Title: STAGE 1 ROAD SAFETY AUDIT

**Proposed Residential Development, Churchfields,
Mullhuddart.**

Client: Waterman Moylan Consulting Engineers.

Report reference: 1833R01

Adjacent to the pond, disabled car parking space.

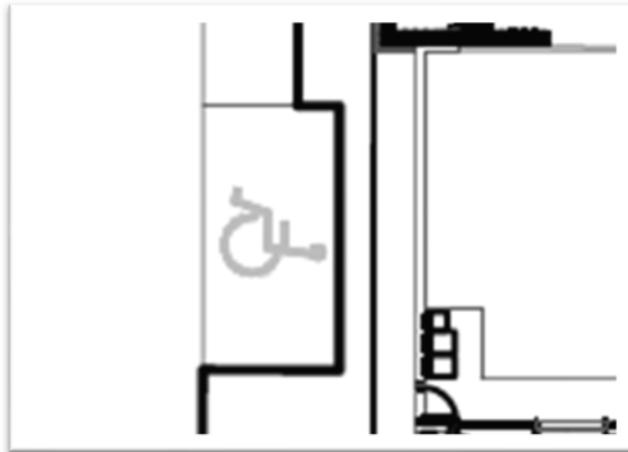
PROBLEM

The presence of the disabled parking space leads to a very narrow footpath. This could result in inaccessibility for mobility impaired pedestrians and lack of a suitably wide access area for wheelchair users.

RECOMMENDATION

It is recommended that the footpath be widened locally at the disabled parking bay and that a dropped kerb be provided to the footpath to provide access from the bay.

3.4	Yes	Yes	The footpath will be widened to allow for suitable access.	Yes
3.5	Yes	Yes	Noted. road markings and a stop sign will be added to ensure that the priority road is identified.	Yes

Drawing 20-074 P4115 Rev -, northern vehicular access.

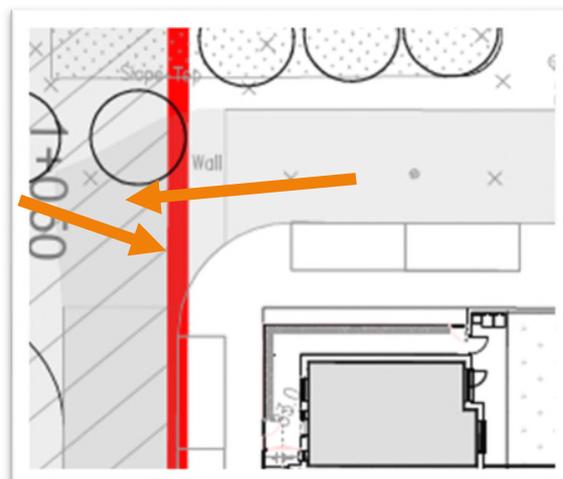
PROBLEM

Drivers may be confused over priority at the northern vehicular access due to the horizontal alignment at the junction. A lack of stopping sight distance on the through route and visibility from the sideroad could lead to collisions.

RECOMMENDATION

It is recommended that the priority be established and that suitable visibility be provided. Stop control should be provided on the minor arm during the detailed design stage.
